Metro Inner-South Joint Development Assessment Panel Agenda

Meeting Date and Time: Monday, 30 January 2023; 9.30am
Meeting Number: MISJDAP/127
Meeting Venue: City of Fremantle
151 High Street, Fremantle

Development Description:	Construction of a three (3) storey mixed use (shop, office, liquor store-small and child care premises) development
Applicant:	PTS Planning
Owner:	Silverleaf Investments Pty Ltd
Responsible Authority:	City of Fremantle
DAP File No:	DAP/22/02352

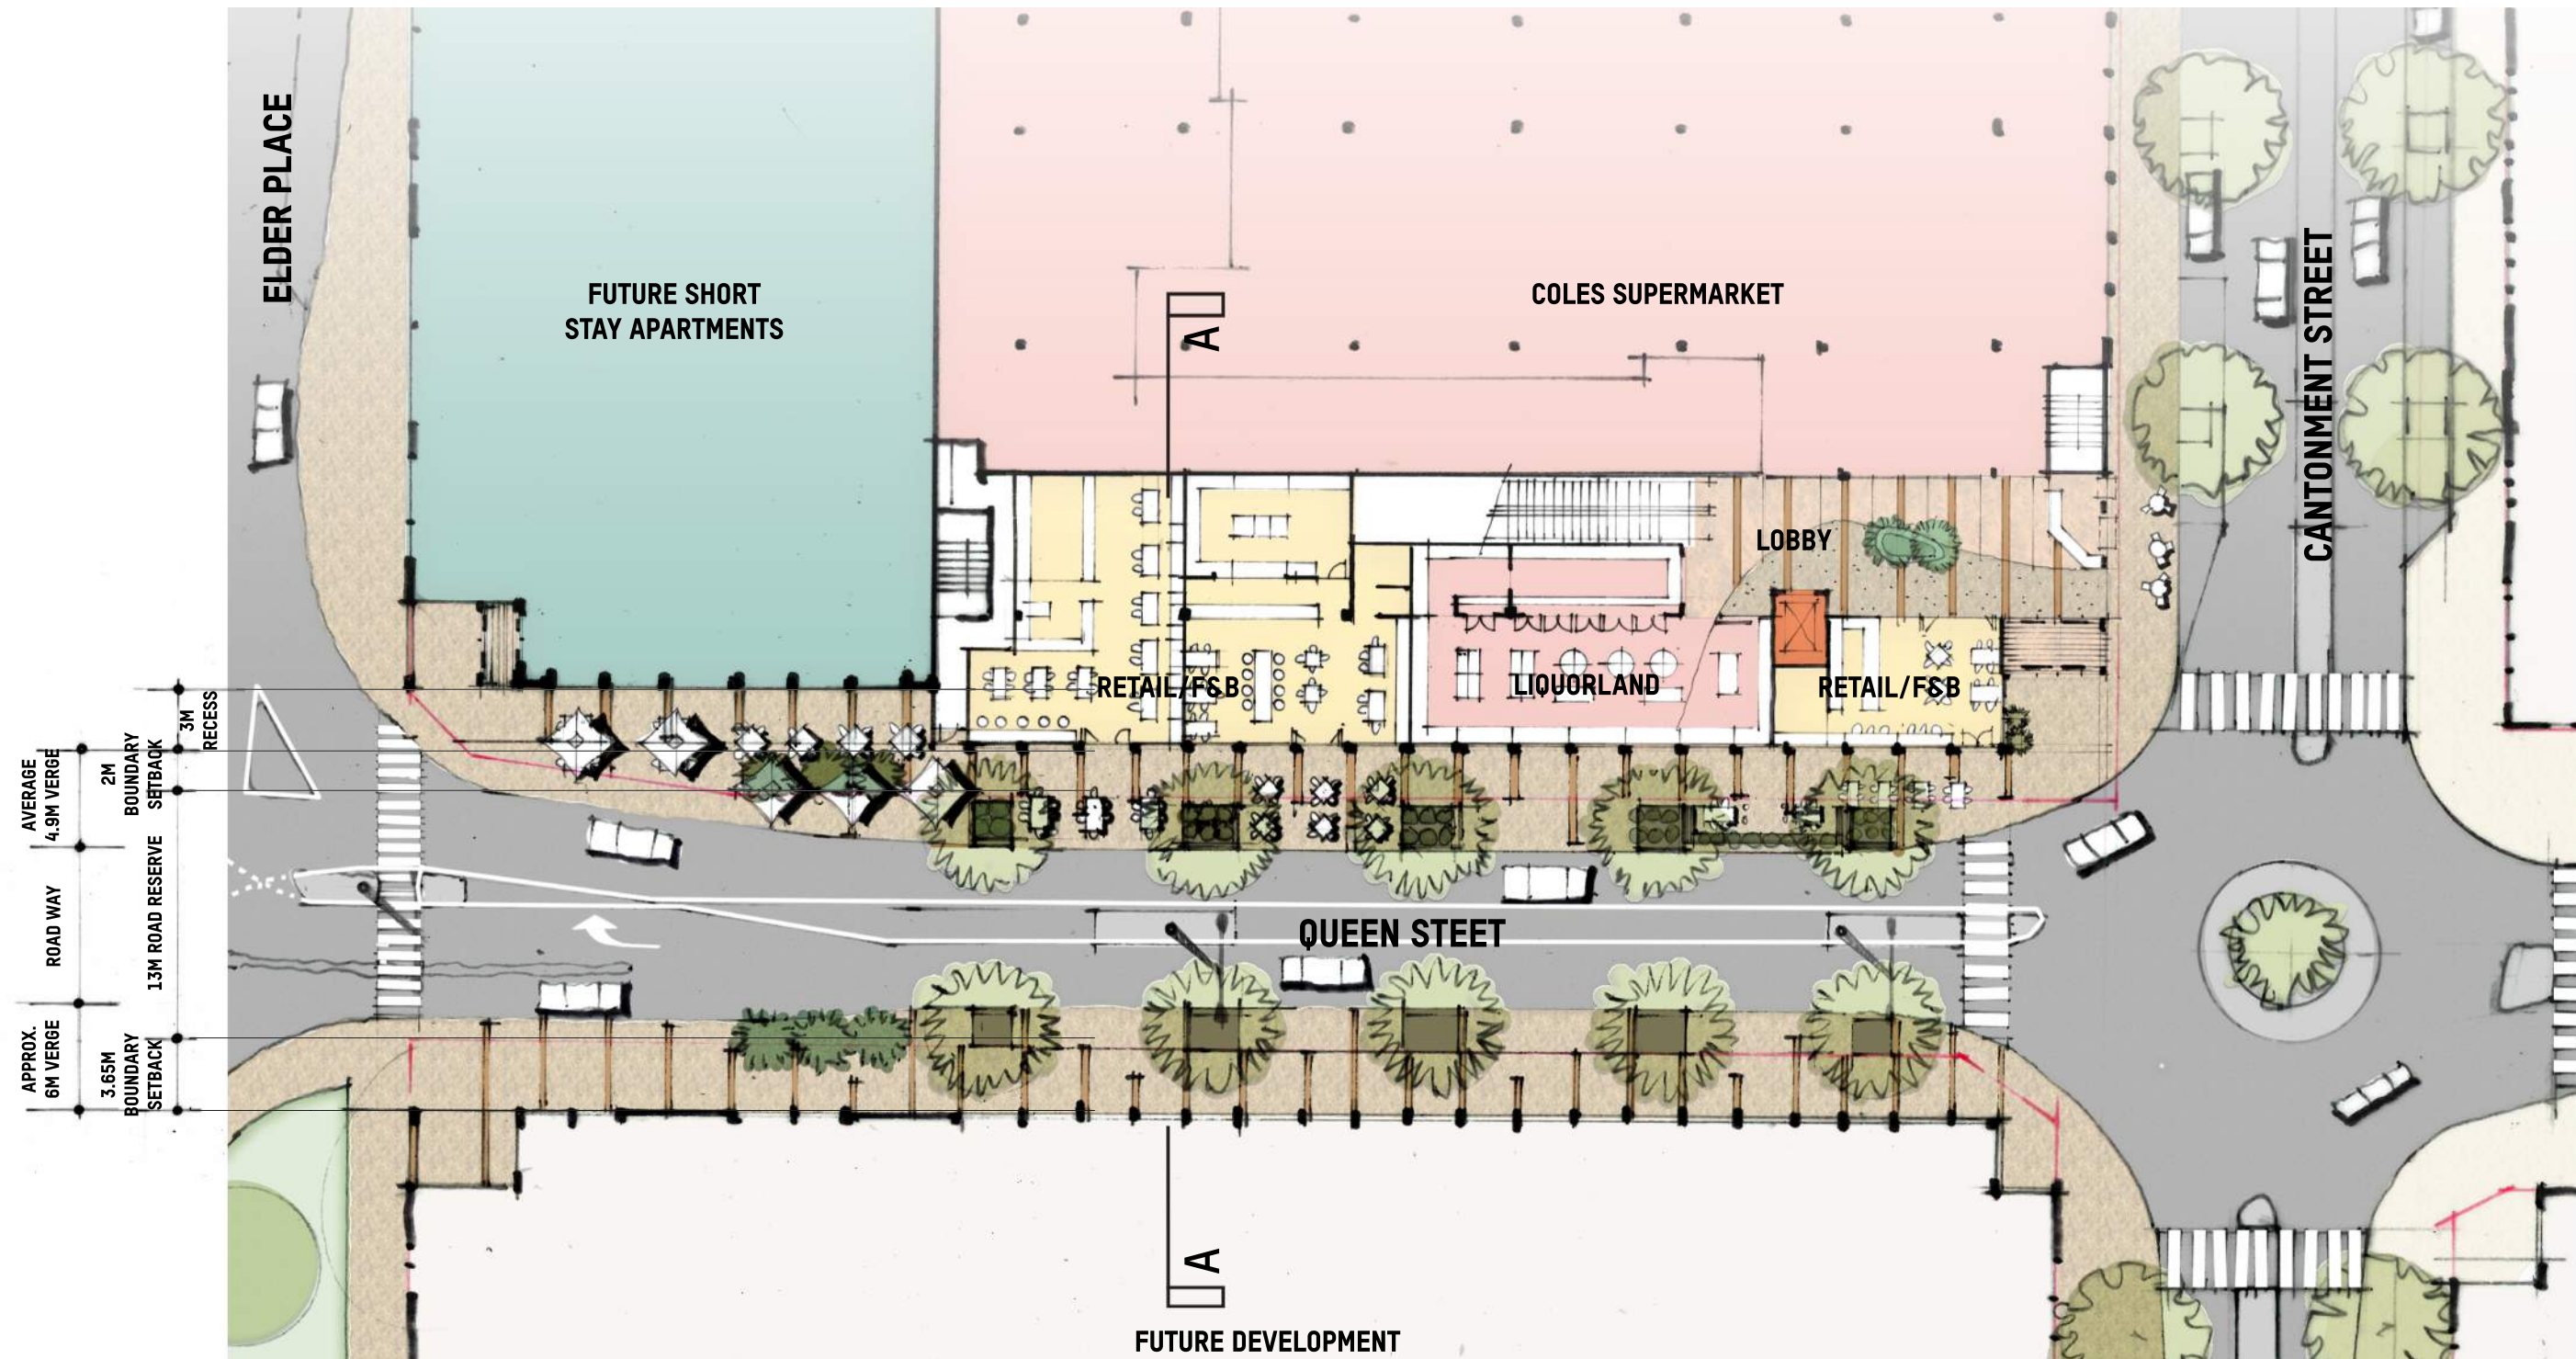
- Refine the canopy design to reduce its bulk and provide the design approach for draining rainwater

- Canopy design has been refined to provide a more slim-line aesthetic and simplify rainwater drainage.

GROUND LEVEL
INCREASED 3.65 SETBACK

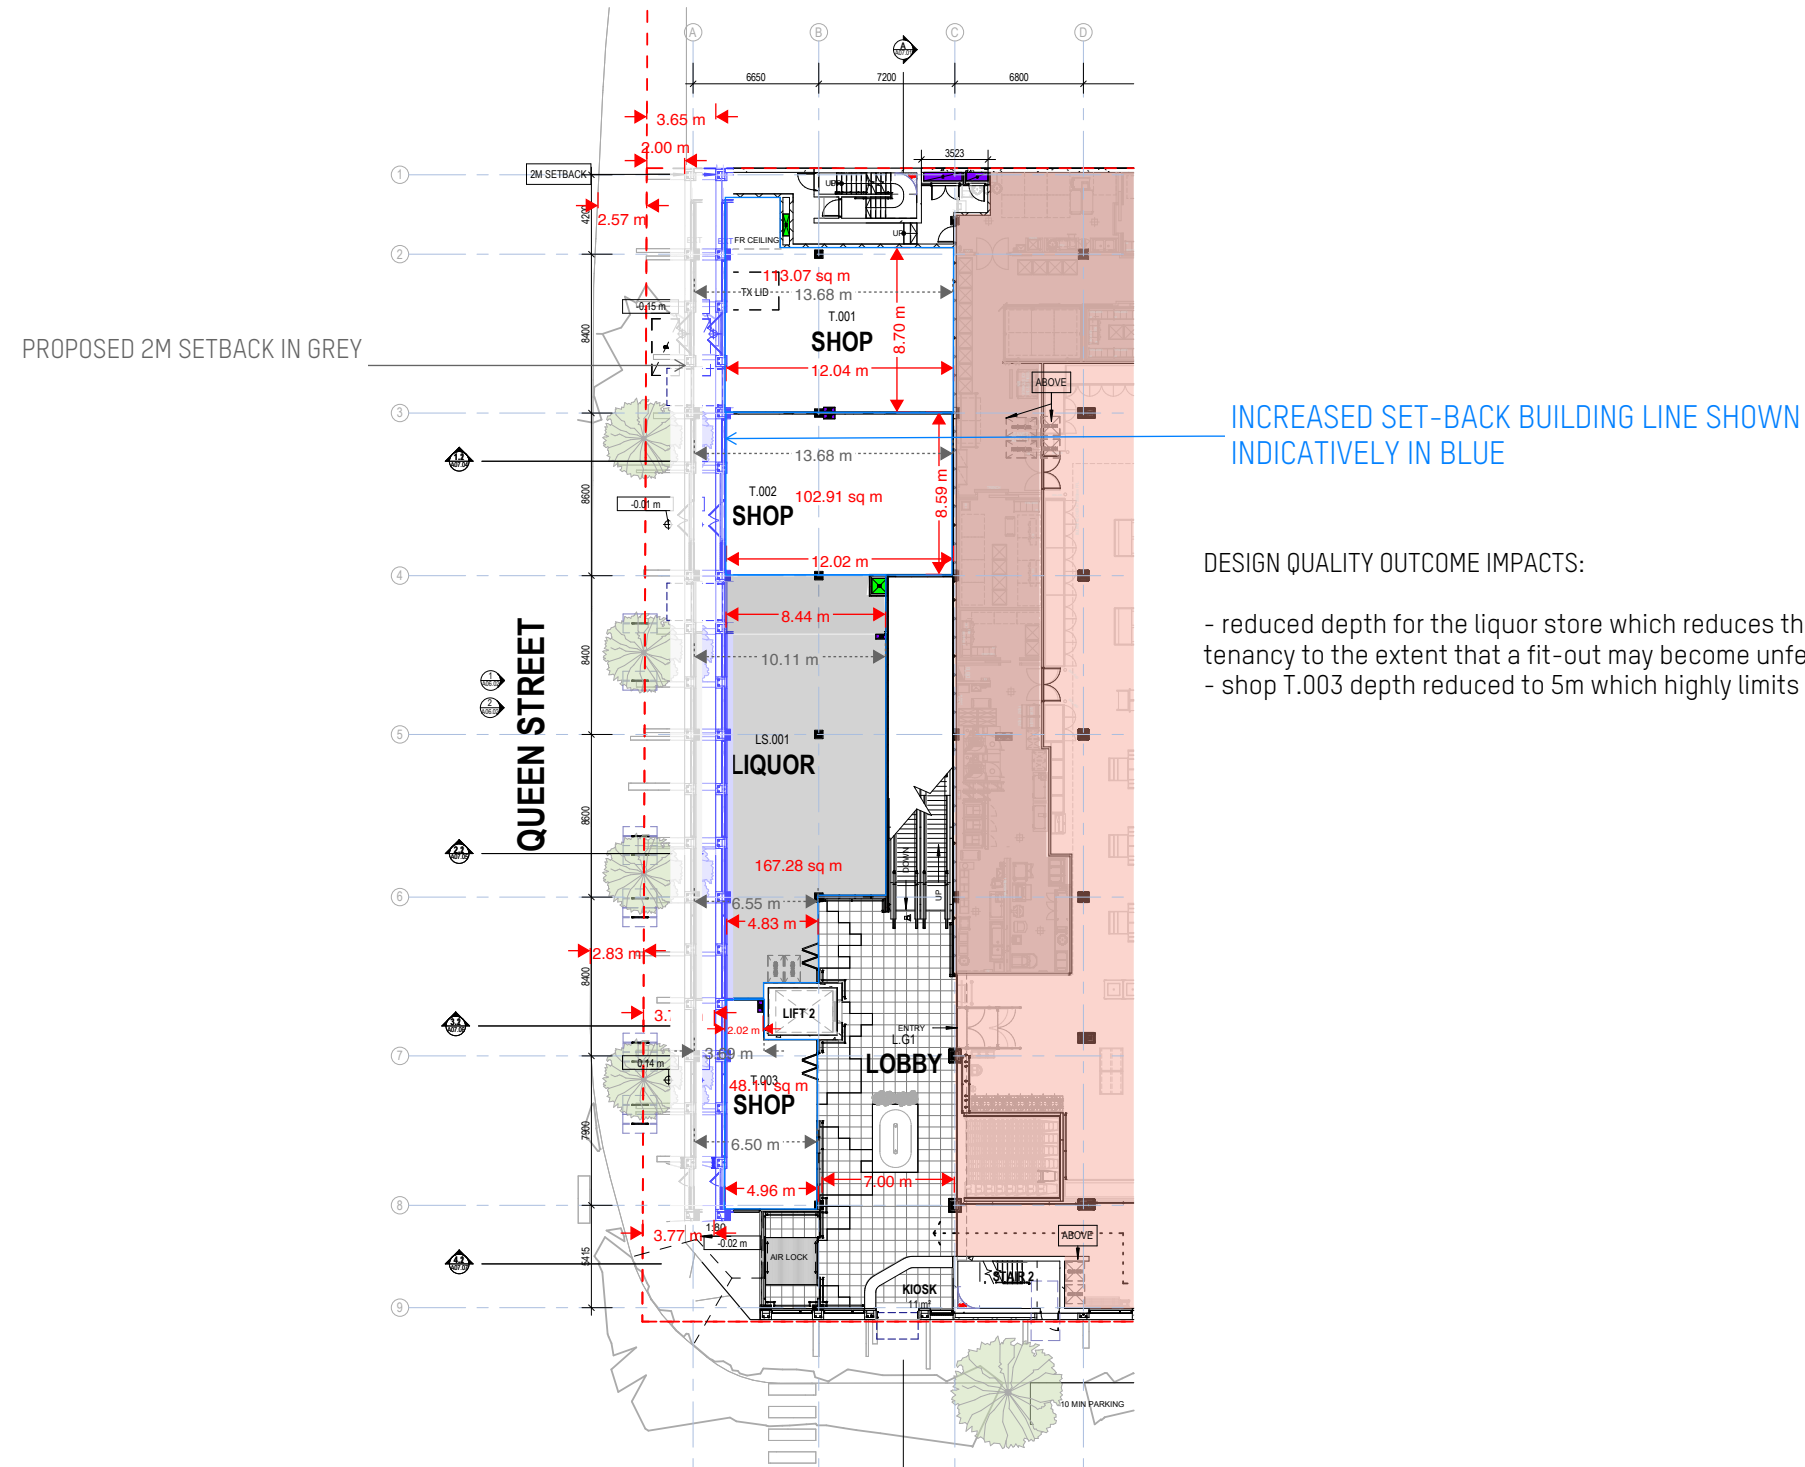
The key issue is the setback to Queen Street. The application is proposing a 2 metre setback while Condition 9 requires the plans to be amended to be setback 3.65 metres.

We also raise the validity of the condition as it will involve significant design changes to the plans. It is not as simple as setting the whole building back or slicing area off the Queen Street frontage as there are a number of design implications for the whole site which will need to be further investigated. Any design change may also involve a reduced level of car parking which would be a further variation which would not have been approved by the JDAP.

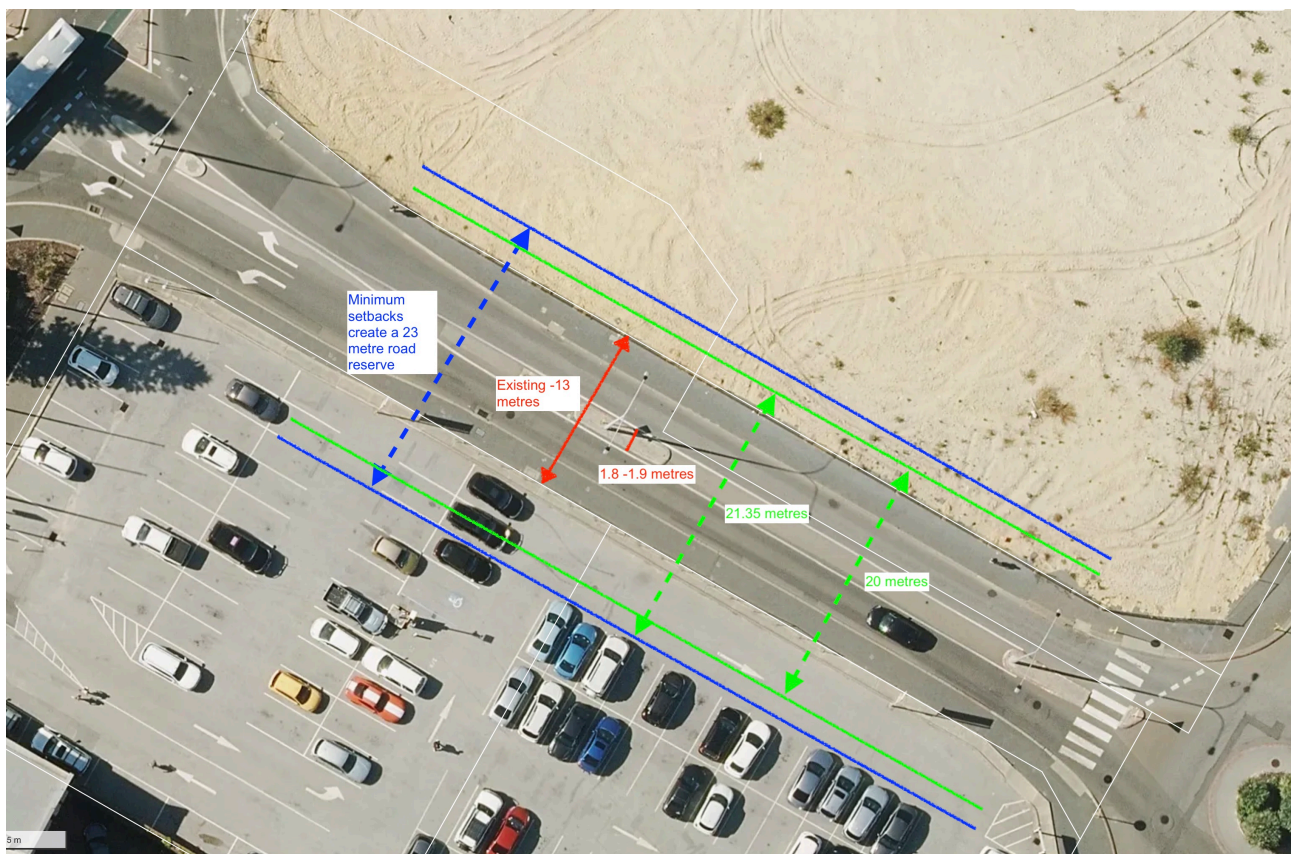
The arial below seeks to explain the proposed setbacks and our request for the JDAP to support the reduced 2 metre setback.

Queen Street currently has a 13 metre road reserve, which includes a lane in each direction, a 1.8 to 1.9 metre median strip and footpaths on each side (indicated in red).

Under LPS5, the road reserve would be 23 metres (indicated in blue)

Condition 9 - Prior to the issue of a building permit, ~~the plans shall be amended to include a building setback of a minimum of 3.65m from the Queen Street boundary~~ the applicant/owner is to prepare detailed plans for the improvements to the Queen Street verge, which is to include street trees, paving, street furniture etc. The plans are to be approved by the City of Fremantle with the works undertaken by the applicant/owner, at the applicant/owner's expense, prior to occupation of the development.

Analysis - Section A

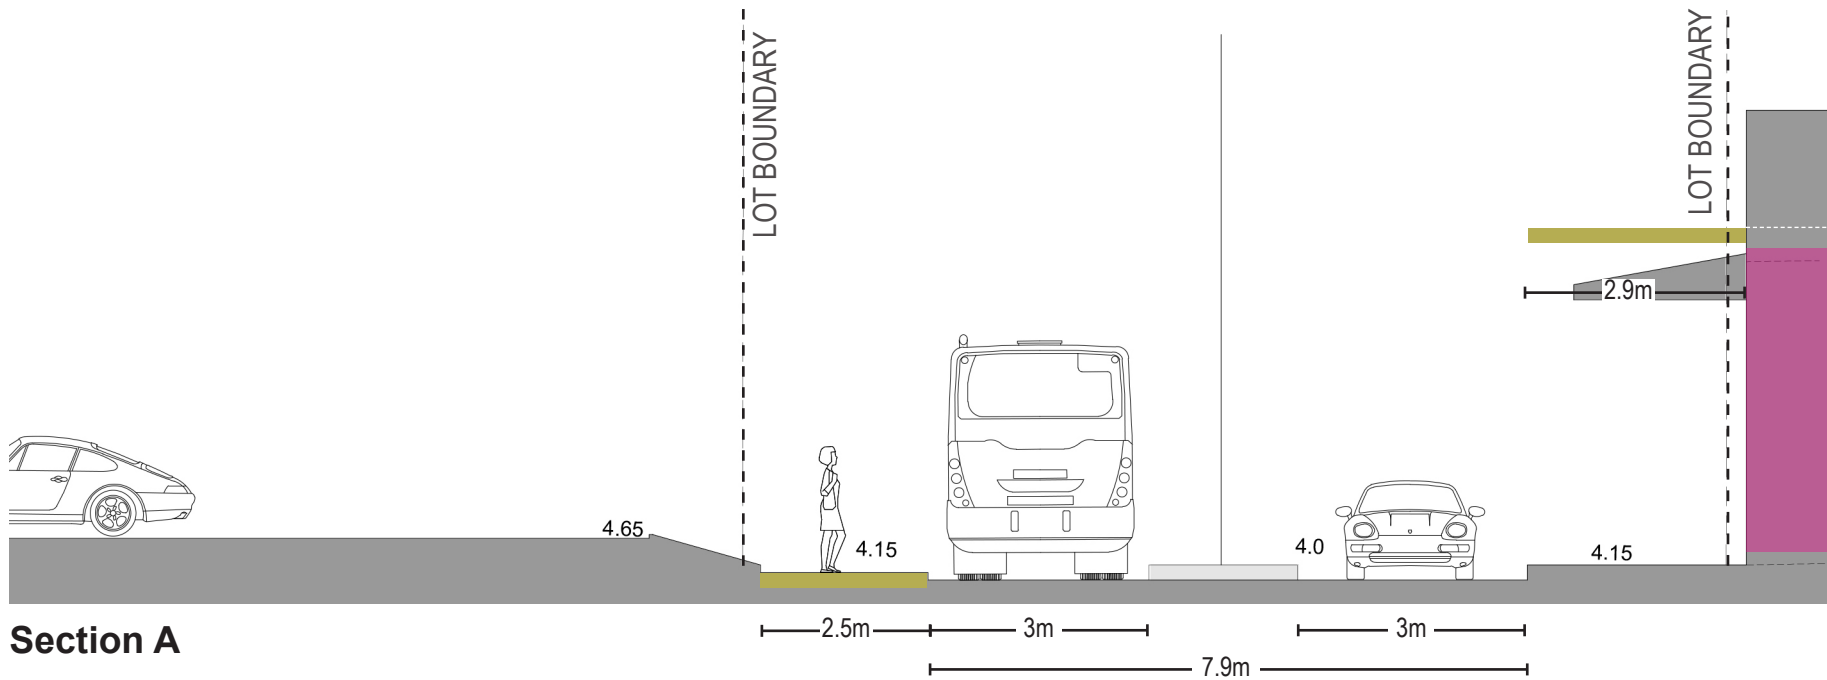
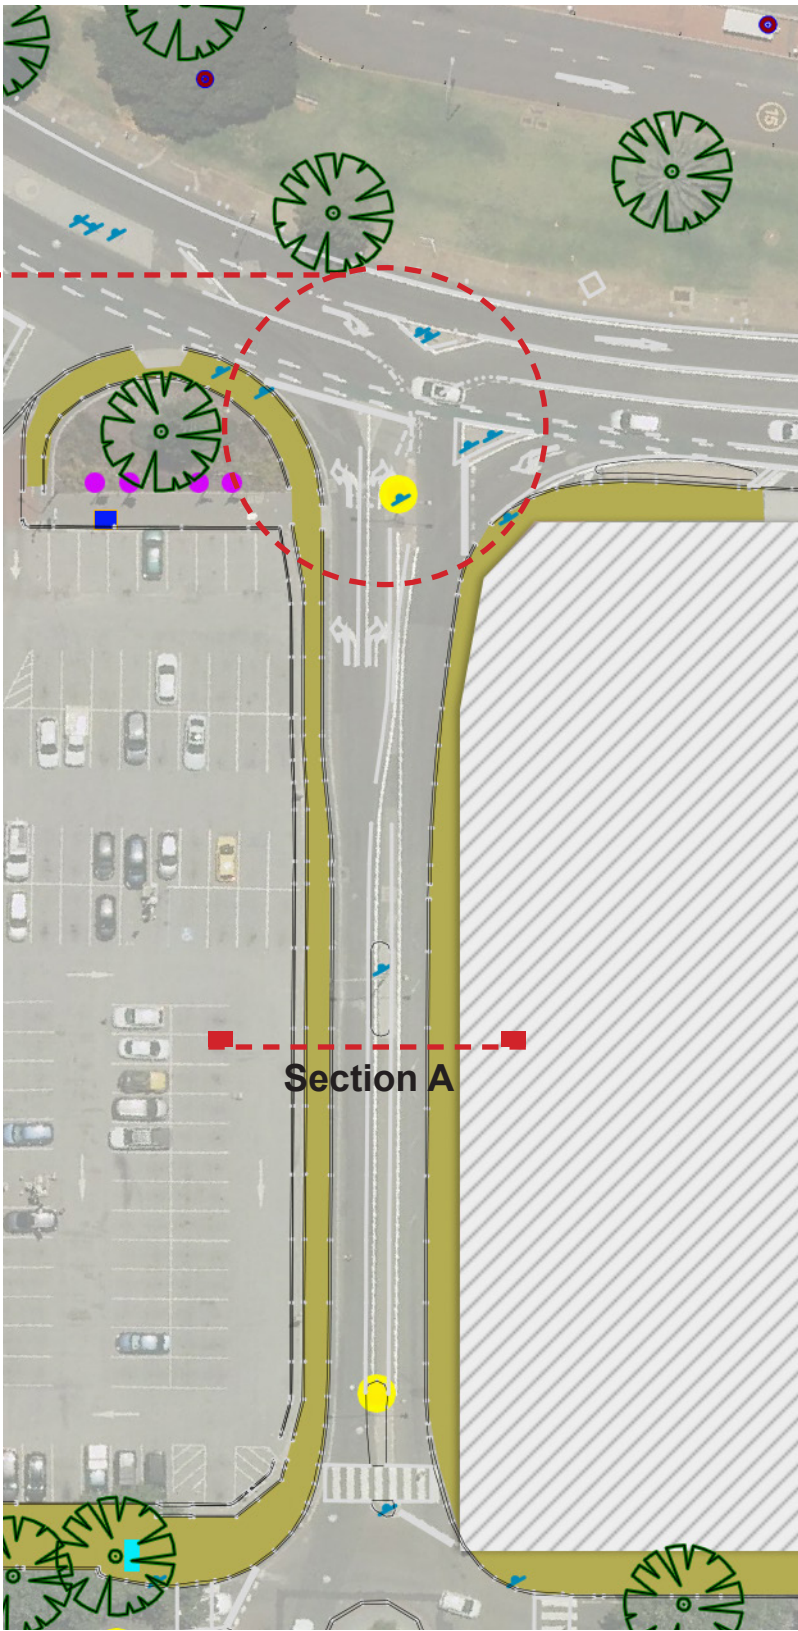
- **Intersection** - Lack of a legible Pedestrian Crossing to Queen Street
- **Foot Path** - Narrow foot path/
- **Street Trees** - Lack of Street Trees, no shade especially in summer
- **Frontages/ Sense of Enclosure** - Lack of Amenity, no active frontages, not enough enclosure on the southern side/ Wilson Carpark
- **Issues** - Contaminated site restrictions
